Palo Verde Nuclear  
Generating Station

**Subject: Palo Verde Nuclear Generating Station (PVNGS) Unit 3  
Docket Nos. STN 50-530  
Unit 3, Refueling 10, Outage (U3R10) Steam  
Generator Tube Inspection Request For Additional  
Information (RAI) Response**

**Arizona Public Service Company's Response to Unit 3, Refueling 10,  
Outage (U3R10) Steam Generator Tube Inspection Request for  
Additional Information (RAI)**

REQUEST FOR ADDITIONAL INFORMATION FOR  
ARIZONA PUBLIC SERVICE  
PALO VERDE UNIT 3 STEAM GENERATOR TUBE  
INSPECTION REPORT FOR THEIR 2003 OUTAGE  
DOCKET NO. 50-530

Figure 1

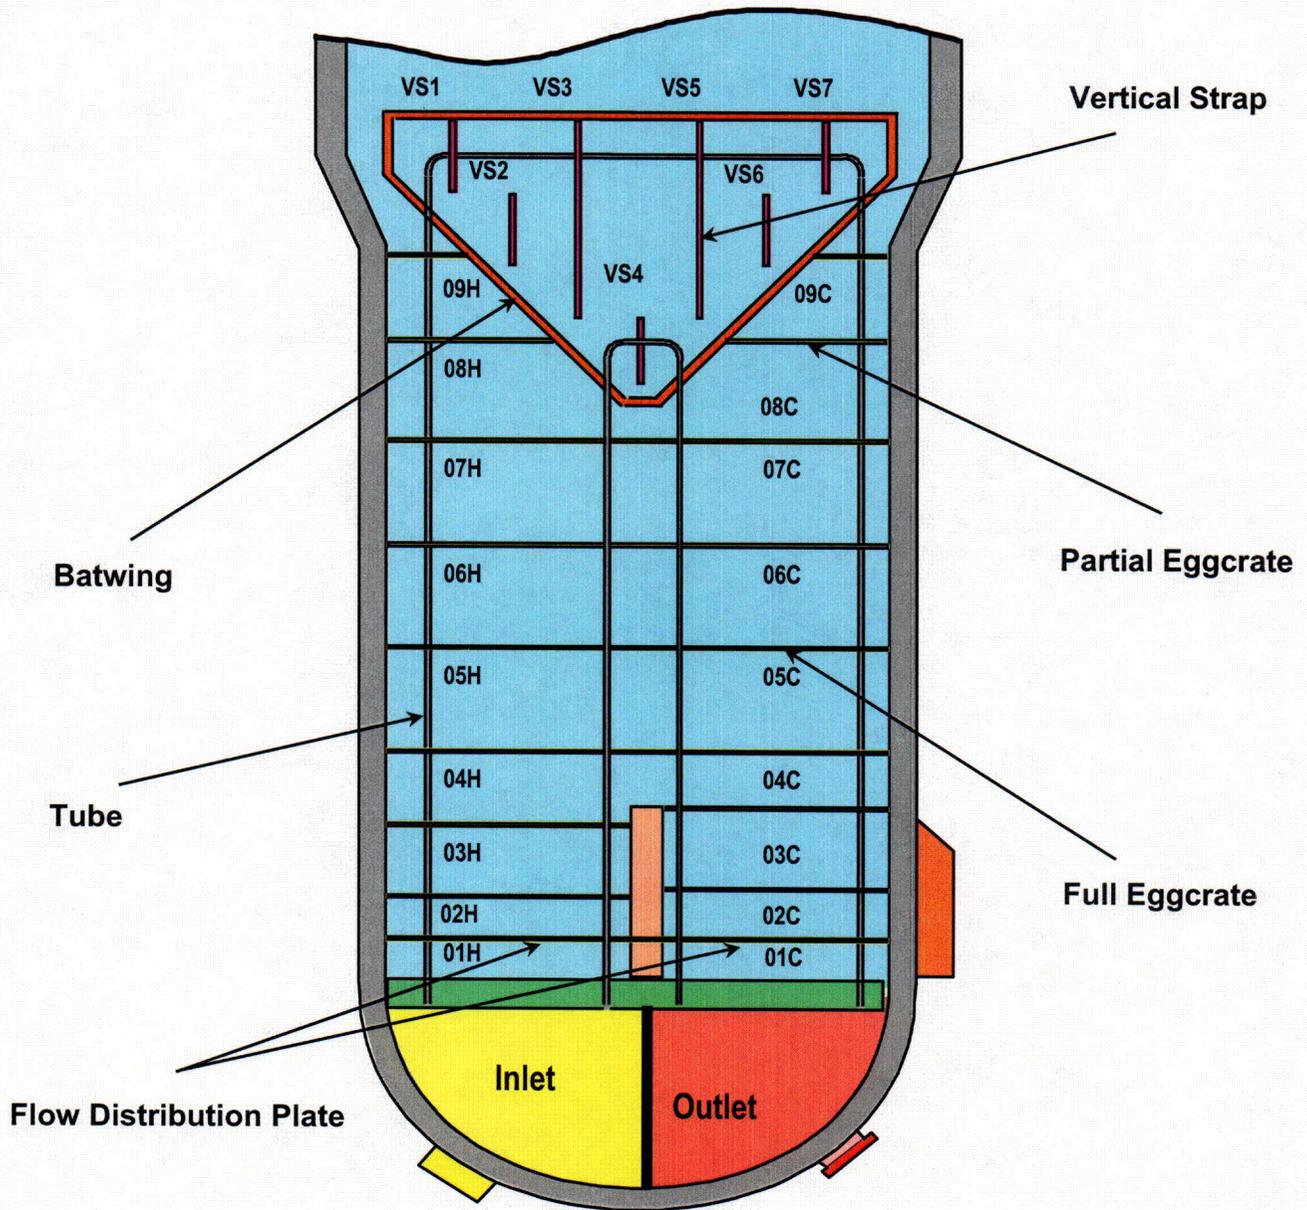
1. Rotating coil (RC) examinations were performed in the upper cold leg (arc) region based on the results from U1R10. Please discuss the results of the examinations performed in this region during the 10th refueling outage at Unit 3 (U3R10).

An upper cold leg (arc) region supplemental inspection with Plus Point was performed in Unit 3 based on a Palo Verde Nuclear Generating Station (PVNGS) Degradation Assessment (DA) of U1R10 findings. In the U1R10 inspection, 26 tubes were found to have Stress-Corrosion Cracking (SCC) indications at support locations on the cold leg side of the upper bundle (See Figure 1 - tube supports 07C-VS5). All indications were detected by bobbin coil. These indications represented a first time discovery of cold leg side SCC in the upper bundle region at PVNGS. Hot leg side (07H-VS3) ARC Region degradation has been detected in all three units for 10 years.

An Eddy Current Testing (ECT) expansion using rotating coil (Plus Point) was conducted in the length of tubing from 07C-VS5 to determine if freespan axial SCC defects existed in the same region. The inspection revealed no indications within the freespan. As such, the bobbin coil inspections were considered adequate for detecting Outside Diameter Stress-Corrosion Cracking (ODSCC) at vertical strap and eggcrate support locations.

The subsequent Unit 3 DA, performed in preparation for U3R10, determined that this first time discovery of Unit 1 axial ODSCC on the cold leg was limited to an area of the steam generator found to contain a higher level of deposits as indicated via a scale profiling technique licensed through Westinghouse (see Figure 2). Although, Unit 3 was not expected to have similar deposition profiles, based on the extent of steam generator modifications designed and implemented in Unit 3 to limit dryout in the upper bundle region of the steam generator, as a conservative measure the U3R10 inspection plan included a freespan upper bundle cold leg exploratory sample program with Plus Point.
